COUNCIL ASSESSMENT REPORT

HUNTER AND CENTRAL COAST REGIONAL PLANNING PANEL

PANEL REFERENCE & DA NUMBER	PPSHCC-251 – DA2023/00886 - PAN-371287
PROPOSAL	Proposed demolition of existing buildings and erection of a mixed-use development comprising a pub, tourist and visitor accommodation-16 hotel rooms, retail premises and forty eight dwellings and associated works.
ADDRESS	Lot 2101 & Lot 2101 DP 755247 1-3 Brunner Rd Broadmeadow
APPLICANT	George Thomas Hotels (Premier) Pty Ltd
OWNER	George Thomas Hotels (Premier) Pty Ltd
DA LODGEMENT DATE	18 September 2023
APPLICATION TYPE	Development application
REGIONALLY SIGNIFICANT CRITERIA	Section 2.19(1) and Clause 2 of Schedule 6 of State Environmental Planning Policy (Planning Systems) 2021 declares the proposal to be regionally significant development as the: <i>'Development that has a capital investment value of more than \$30 million'.</i>
CIV	\$31,557,409 (excluding GST)
CLAUSE 4.6 REQUESTS	CI4.6 - Height Variation (CI4.3) - 184.6% CI4.6 - Floor space ratio (FSR) Variation (CI4.4) - 46.39%

DATE OF REPORT	12 January 2024

Figure 7 - Ground Floor layout. Source: JSA Studio (16/8/23)

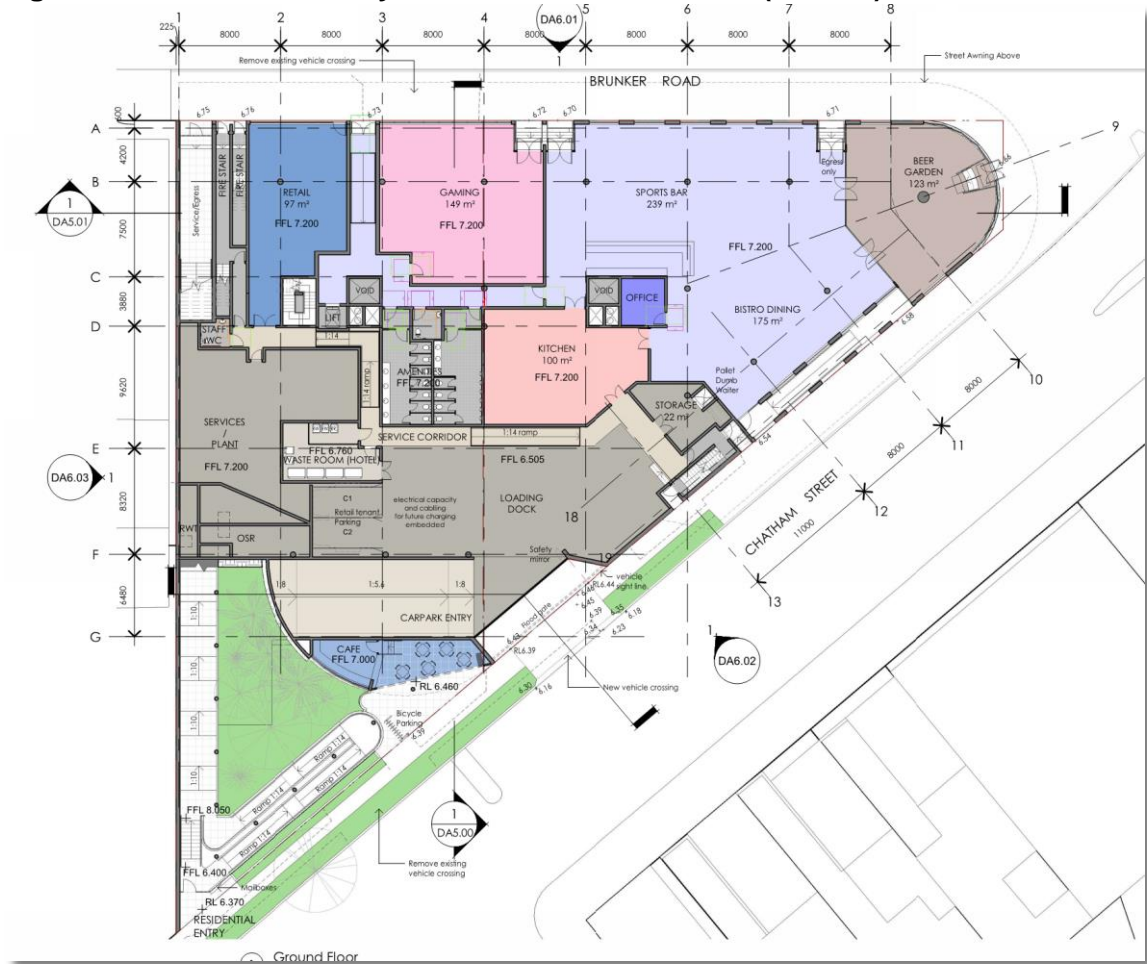
- The ground floor arrangement, movement and interrelationship between hotel and residential spaces also requires reconsideration. The differing security and access needs of the hotel, gaming, hotel accommodation, retail spaces and their interfaces with residential considerations should inform overall site planning and access points. Carparking and access to it, also needs to be considered in this regard.

- o Plant, loading, egresses, extensive residential ramps and the gaming room present a poor interface resolution.
 - o How does waste get from the basement to collection? Note that Residential waste collection must be in conformity with CN policies – irrespective of whether it is intended to be privately contracted. How do the swept paths work for the waste pickup?
